PLANNING AND ZONING COMMISSION MEETING

Subject: Consider the request from David Bentz for a modification to a Planned Unit Development (PUD) for a property located at 1203 North E Street.

STAFF REPORT

PLANNED UNIT DEVELOPMENT (PUD)

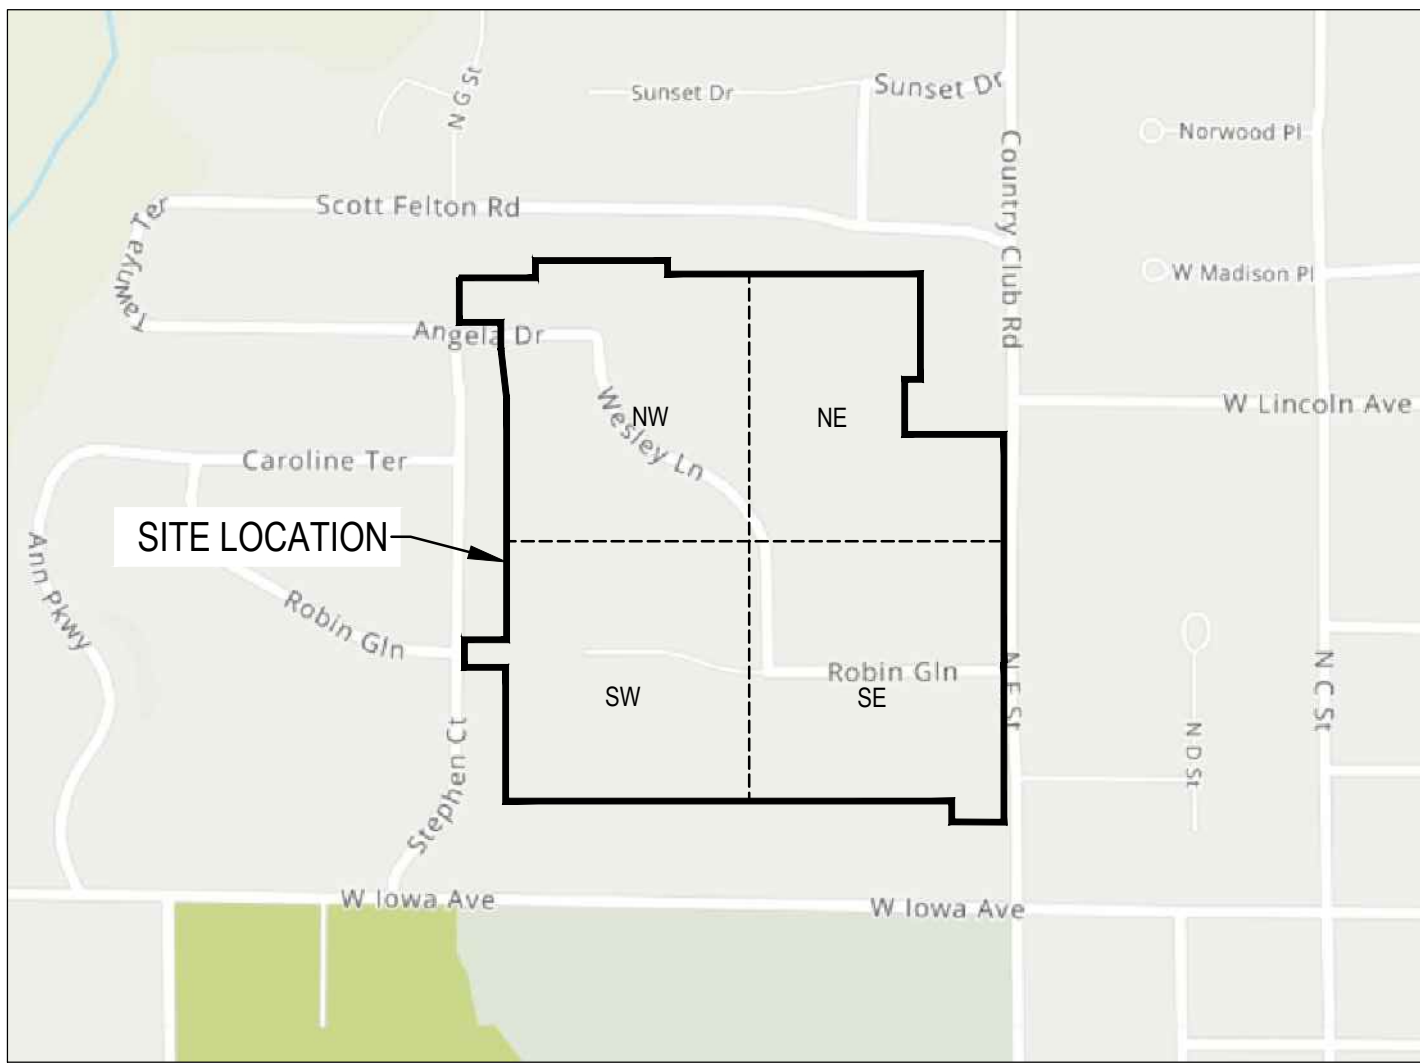
This agenda item was first heard by the Planning and Zoning Commission on January 10th, 2023. At the meeting, the Planning and Zoning Commission remanded the request back to the applicant for additional information and modifications to the submission. The applicant has since revised the application with the following summarized changes:

- The maximum building height for duplex dwellings is listed as 35-feet to roof peek, however duplex dwellings will be a maximum of 2-stories.
- The conceptual plan calls for additional landscaping along the north and northeast property lines to screen the proposed duplexes from adjacent properties.
- The building setback along the north property line is now shown as 30-feet.
- Angela Drive is proposed to extend east and dead-end into a cul-de-sac with a 48' radius. A road connection between Wesley Lane and North E Street is proposed to maintain a through east-west connection. Pedestrian connectivity is proposed between the cul-de-sac and the future road to the south.

1. We attended the presentation give on Tuesday evening, the 10th of January, about the site plan for redevelopment of the Wesley campus. We received an encouraging letter from Ward Phillips inviting those people in attendance and others to meet again on January 19th at 10:00 a.m. at The Village. We also received a personal email in response to our concerns about the drainage and retention of the water that will increase with the housing being built in the near future. We know that Mr. Phillips is aware of the situation, and he indicated that the

We would like to give you a brief history of 1102 Stephen Court. We have lived adjacent to the creek for 51 years. Fifty-one years ago it was a small creek. Three houses were built south of the creek. The city installed a small metal culvert. The creek could handle a normal rain, but during a torrential down pour of four or more inches the creek would overflow its banks and proceed to the street and flood the street. When The Village began sending more water in our direction, a large cement storm sewer was installed by Veenstra and Kimm Inc. which was approximately fourteen years ago.

The Village did dig a dry pond to help with the drainage and runoff. In recent years The Village changed the landscaping around the dry pond with brick retaining walls. The dry pond has overflowed its banks in a torrential down pour. The stormwater comes down on our property, swirls, and then flows into the creek. There is a rapid current. When the storm sewer can no longer keep up with the rushing water it then spreads out into our yard. Fortunately it has not flooded the street. Can this storm sewer handle the existing Village complex plus the new town homes? It is a lot to expect from one lone creek.

Another concern is the erosion. Through the years the creek bank south of our home continues to erode with the passage of water. We have attempted to stop the erosion at our expense by having large rocks placed along the north bank of the creek and above the cement culvert. Our intention was to continue with the addition of large rocks to where our property line ended with The Village. The project stopped because that section became a sheer drop off.

We are not engineers. We do question if this creek is the only solution to drainage and runoff. Can the excess water be diverted in other directions? Can another holding pond and dry pond be a part of the new landscape? We have expressed our thoughts and we wanted to let each of you who receive this email know about our experiences with the dry pond and the creek when Mother Nature is at her worst. *(Sam and Jane Martin, 1102 Stephen Court)*

Additional landscape screening shall be added along the north & east property lines to screen the proposed duplexes from the adjacent neighborhood. The landscaping shown on the master plan is for conceptual purposes only and the exact amount of screening will be determined with City staff during the site planning process.

Stormwater runoff from portions of the existing site discharge offsite undetained and it may not be feasible to capture all of these areas in the proposed condition. Therefore, stormwater ponds & storage will be provided throughout the proposed PUD to capture as much stormwater runoff as possible as deemed acceptable by city staff.
